Wylfa Newydd Project

Request for Non-Material Change no.4

Working Hours

PINS Reference Number: EN010007

Figure 2-1 Before proposed change to haul routes (i.e. as per DCO application)

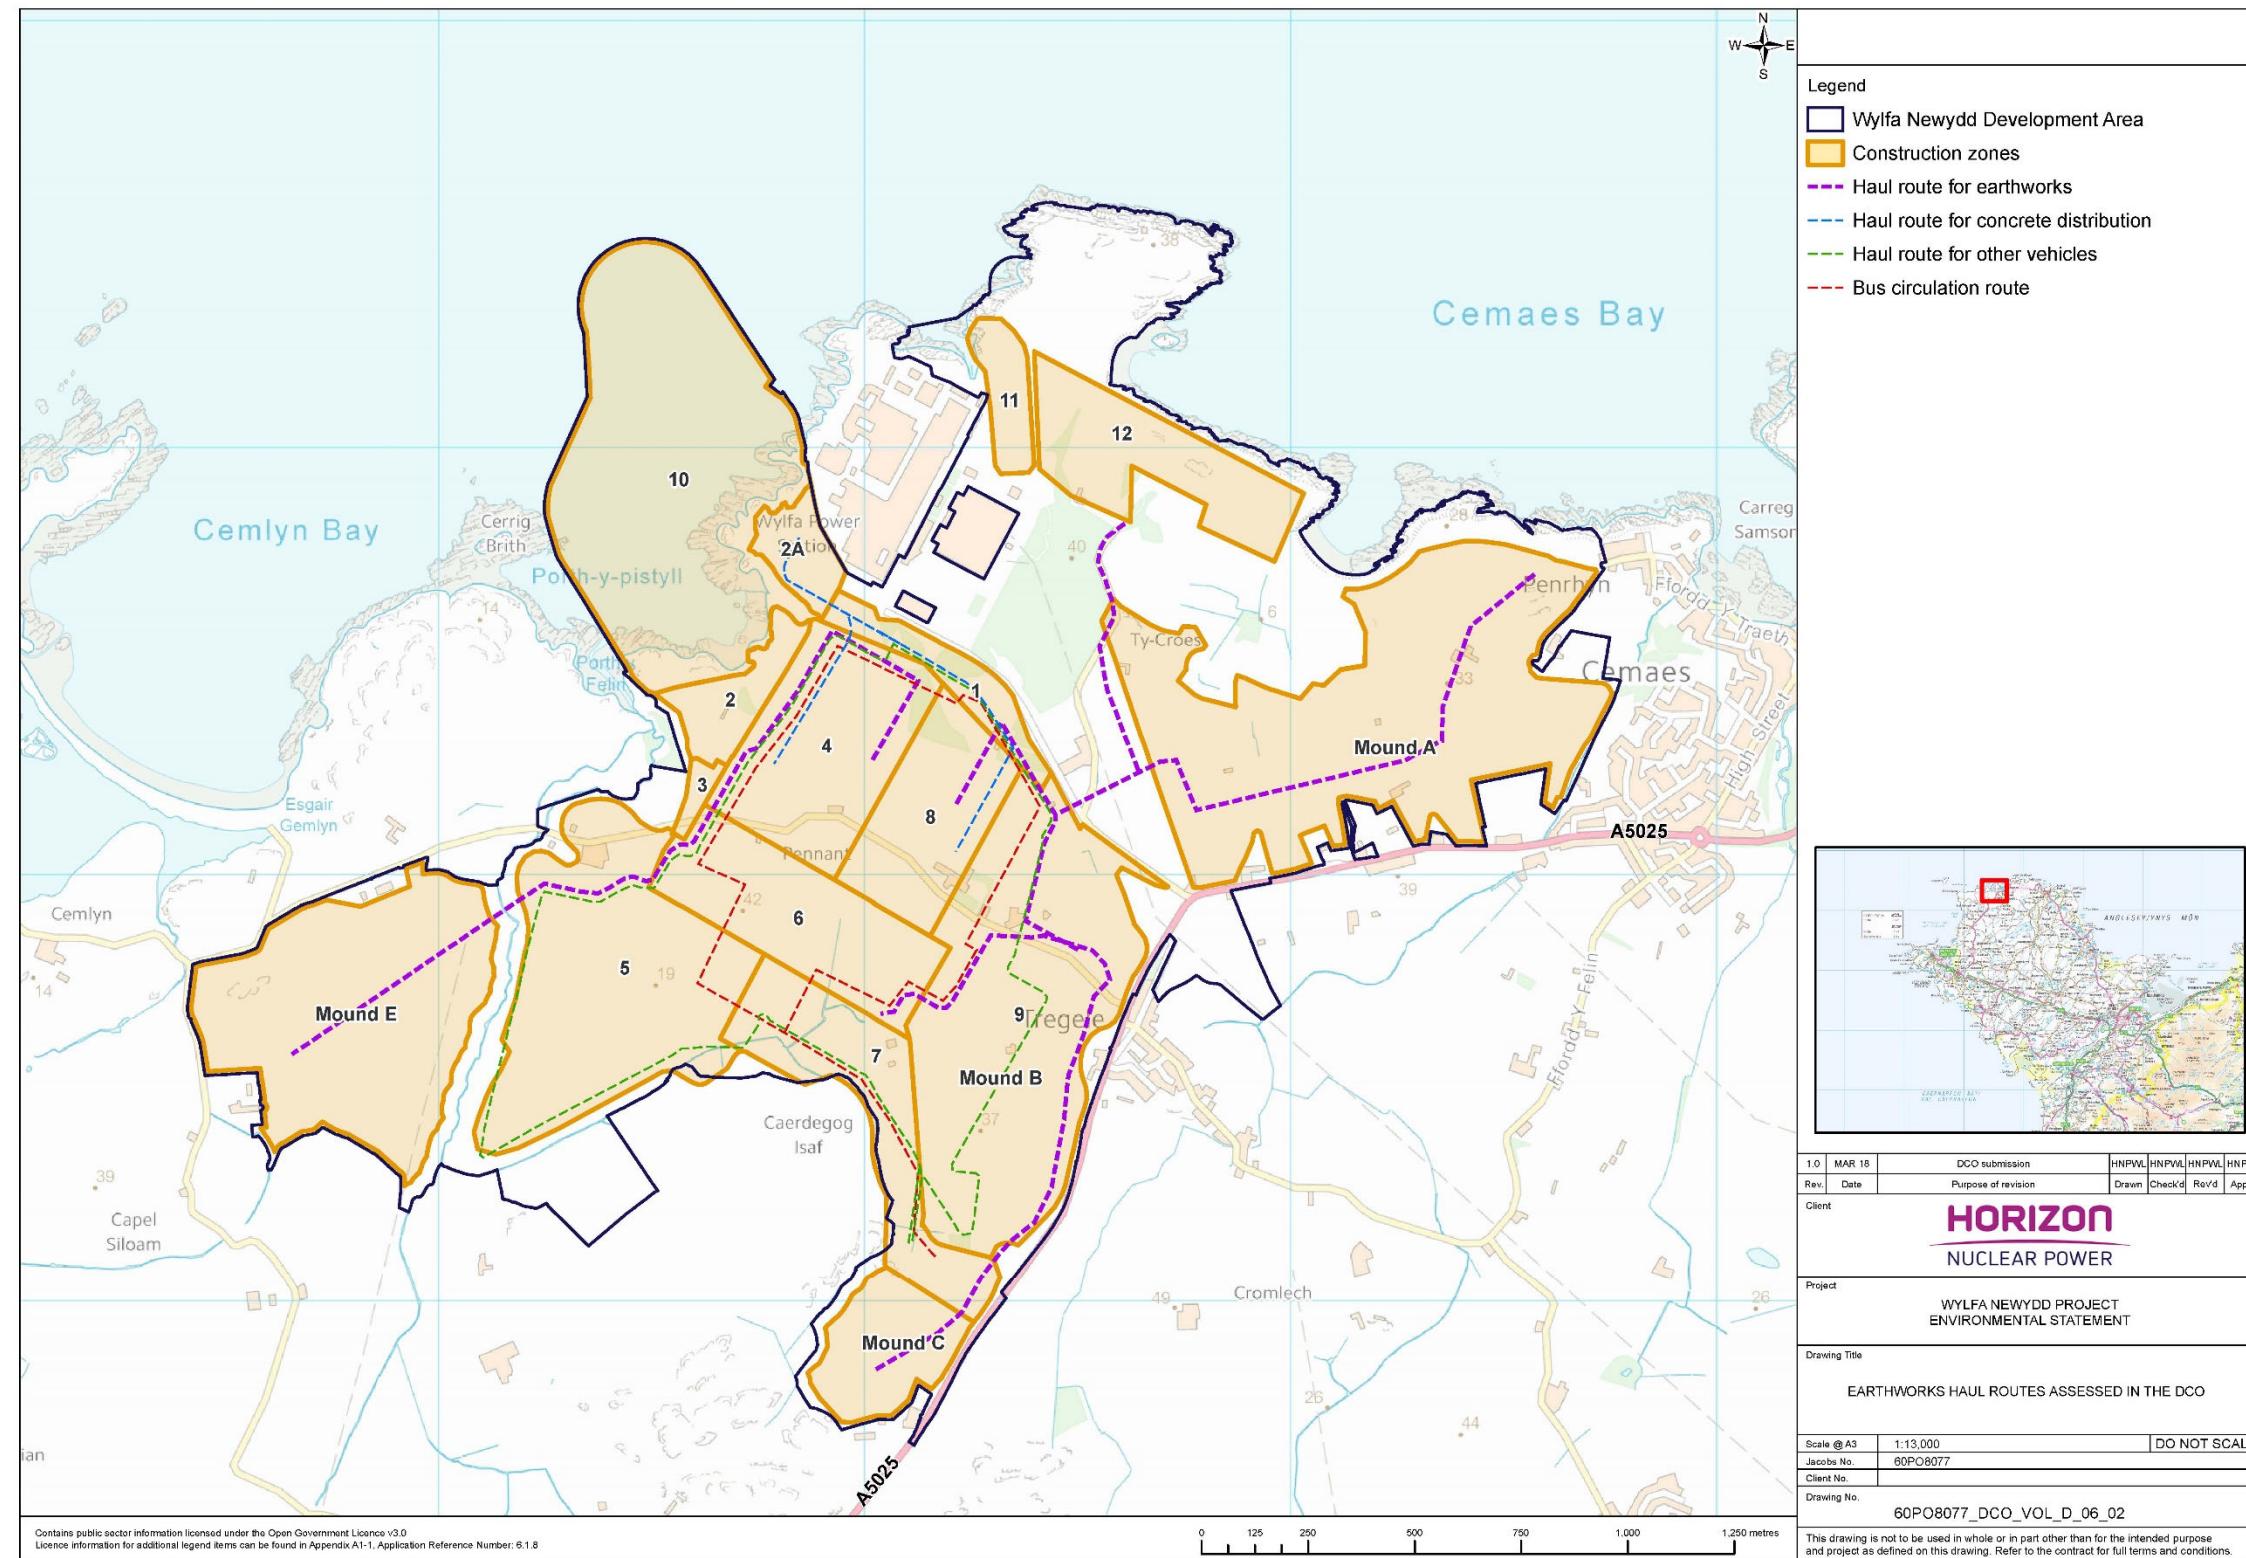
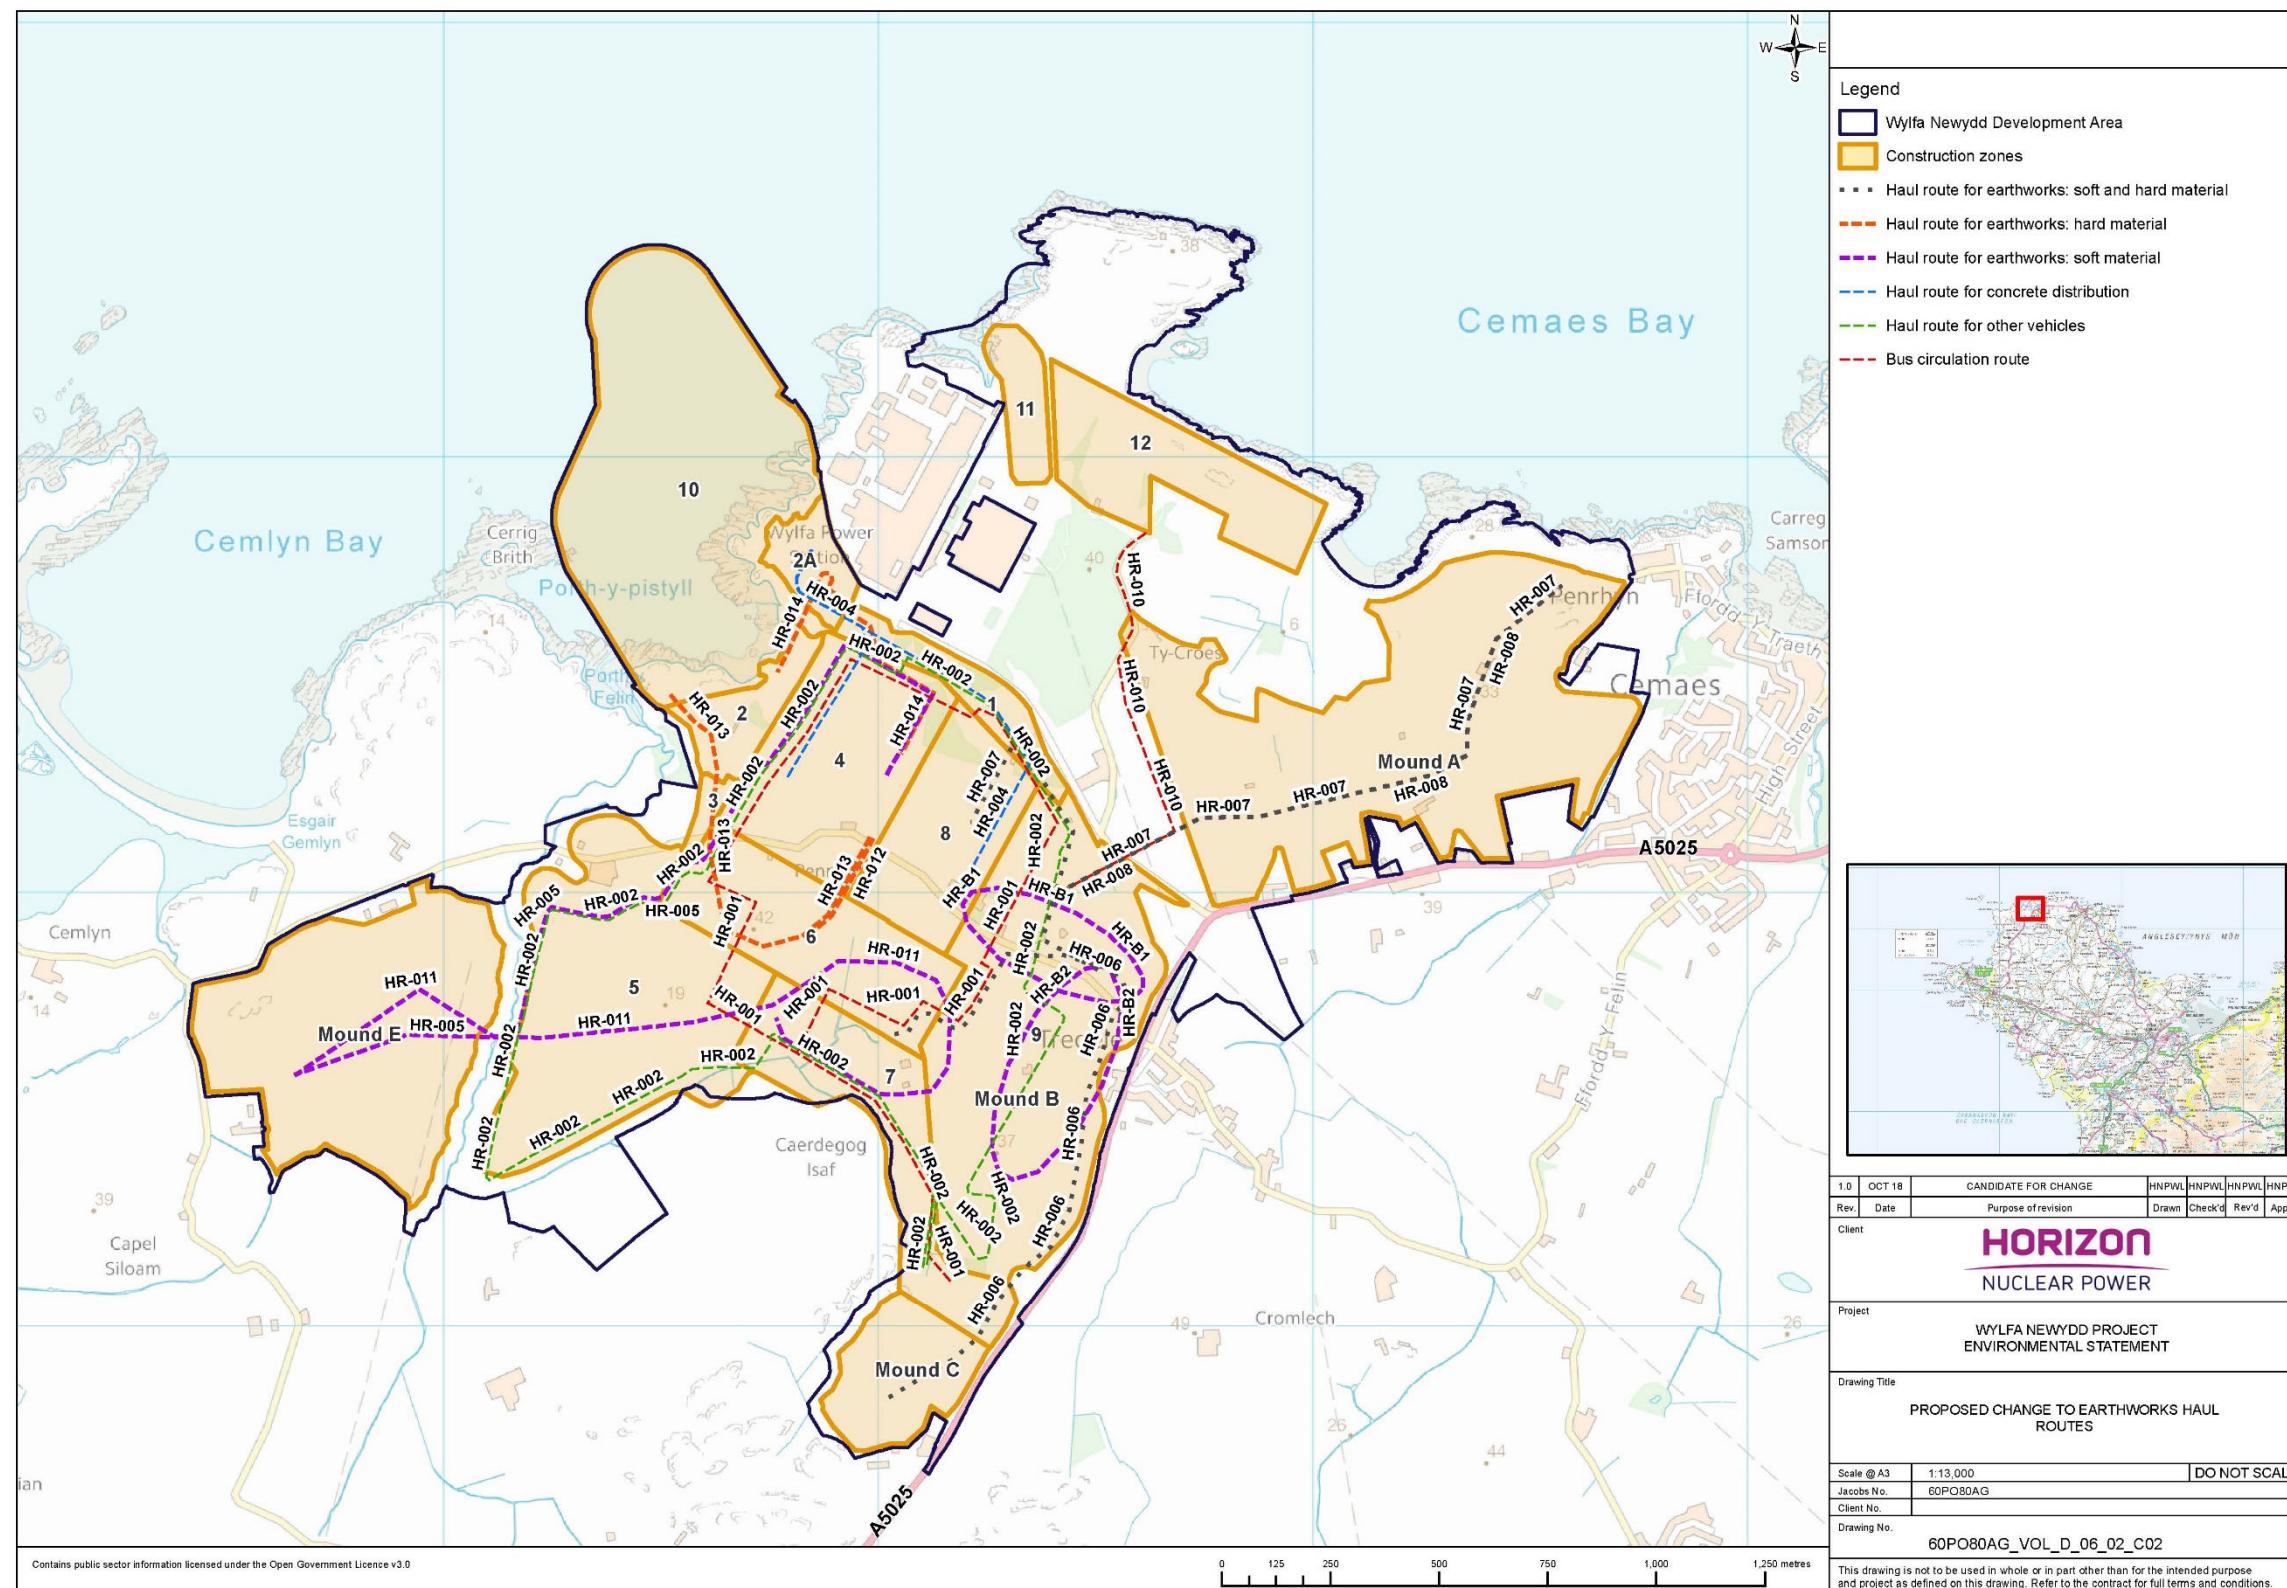
2.2.3 As a consequence of the proposed change and to reduce the potential environmental effects, additional haul routes within the Order Limits are proposed, which form the basis of the further modelling and assessment of the proposed change (see Figure 2-1 and Figure 2-2 for before and after extracts and Appendix 1-2). These include:

- two new circular haul routes (HR-B1 and HR-B2) situated to the west of Tregele in construction zone 9, and one new haul route from construction zone 9 to Mound E (HR-011); these will primarily be used to transport bulk material arising from site grading during the first year of construction to provide fill material needed to construct Mound B1 and E;

- a new haul route from the south extent of the deep excavations (construction zones 4 and 8) to construction zone 6 (HR-012), where rock processing equipment will be situated, which will be used primarily at night so as to avoid plant movements near sensitive receptors;

2.5.37 Before and after extracts showing changes to the new haul routes are shown in Figure 2-1 and Figure 2-2.

Figure 2-3 Amended earthworks haul routes as a result of the proposed change with annotated key lighting sensitive receptors

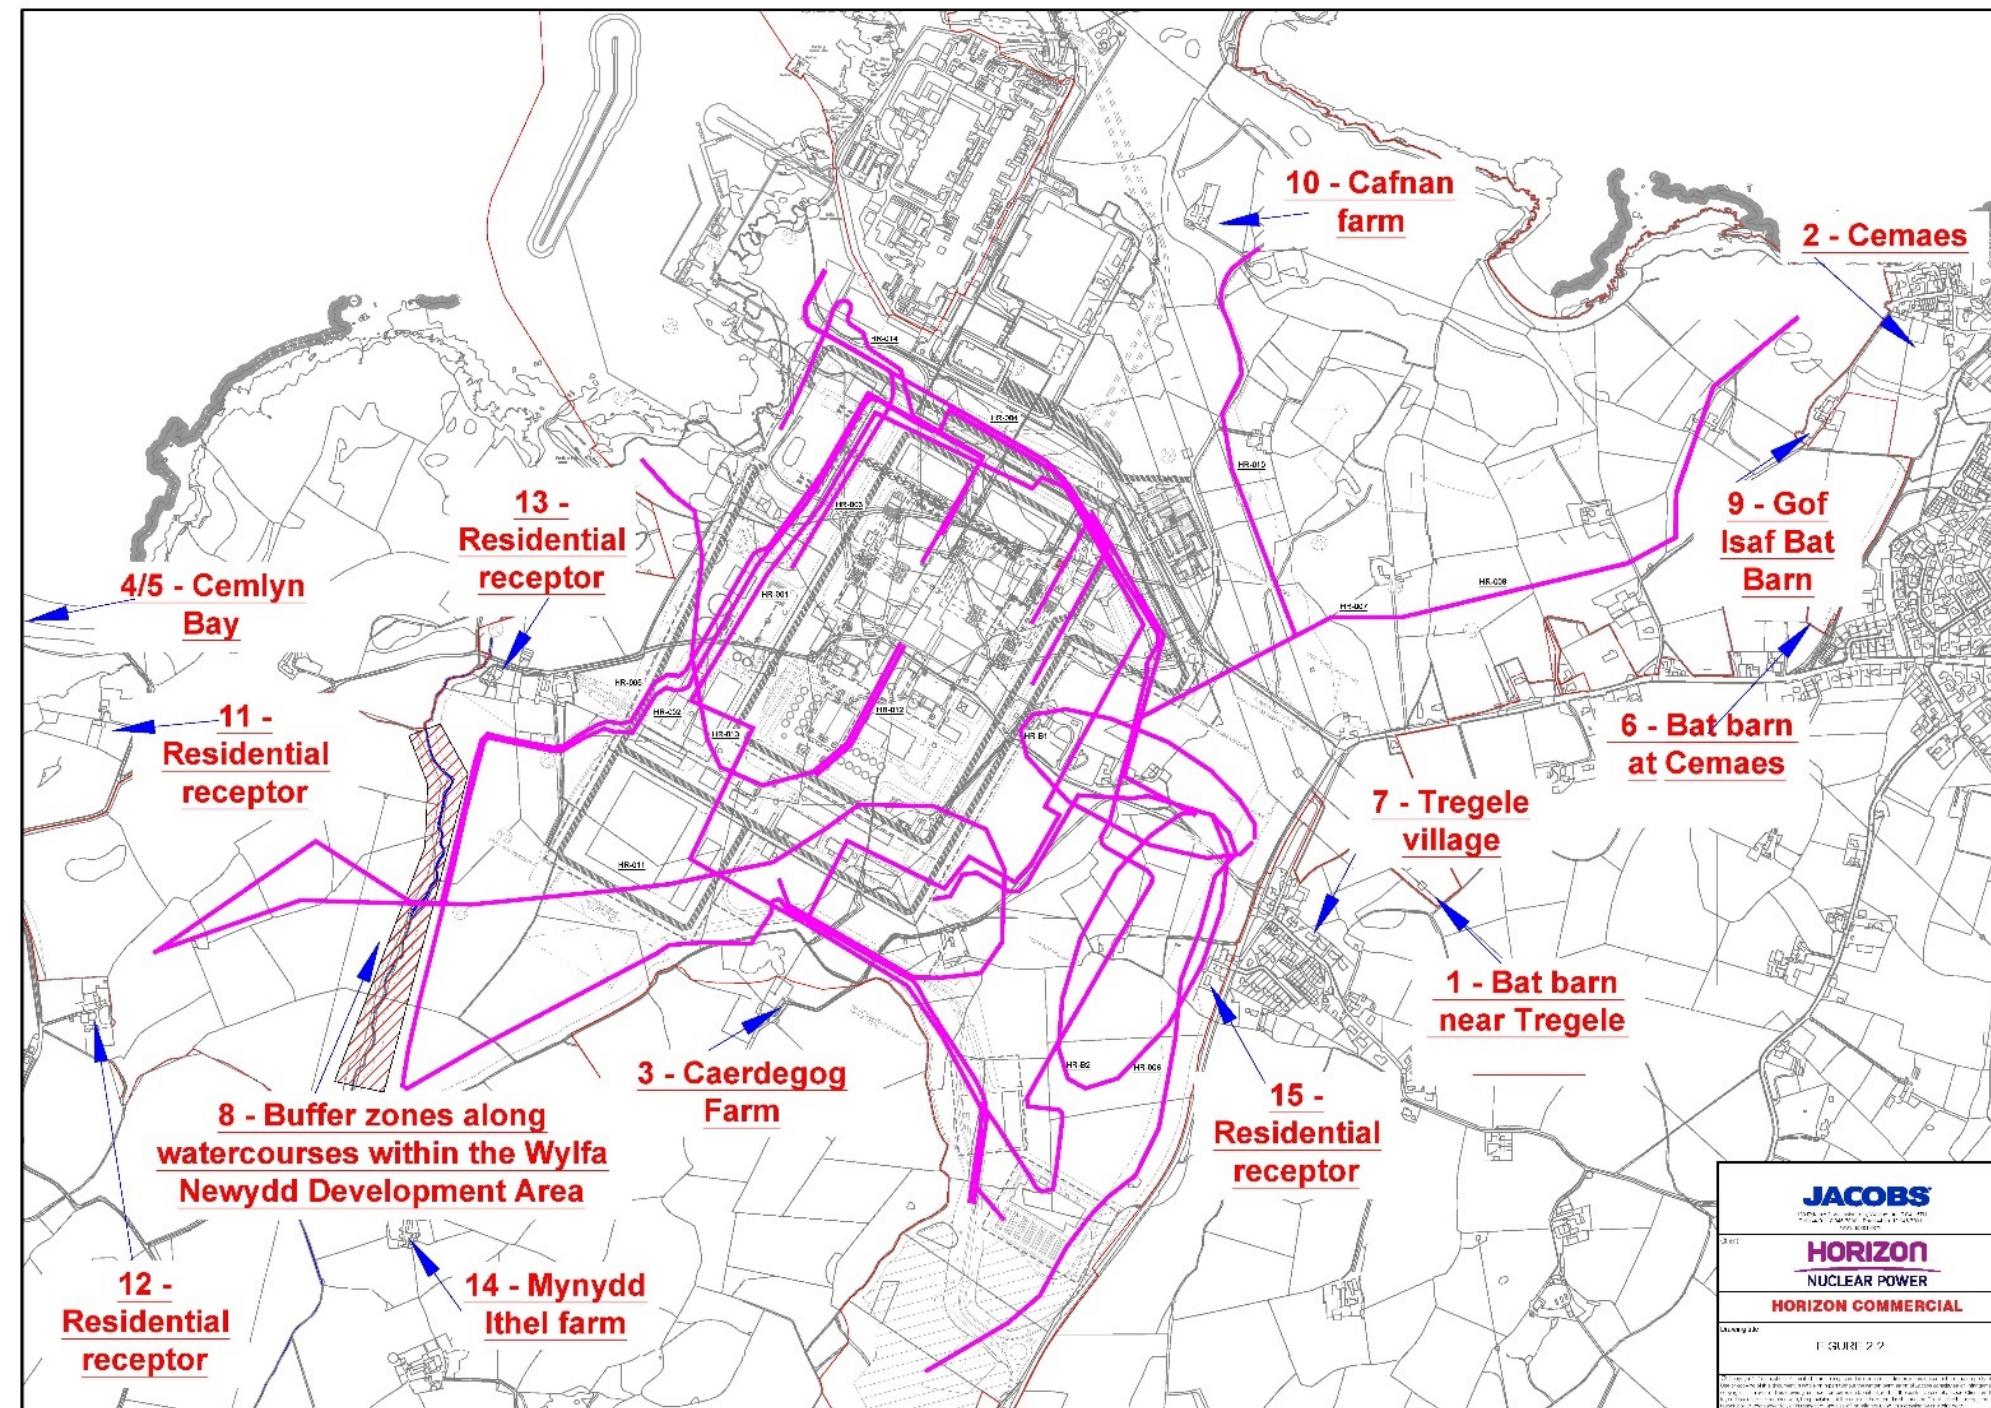
2.5.86 The updated lighting modelling showed no significant effect on residential receptor 12 and 13. An adverse effect from the proposed change was identified at receptor 11, but with mitigation in place which has already been secured in the DCO application, such as issue of blackout blinds to residents of this property, light disturbance at this receptor would be negligible.
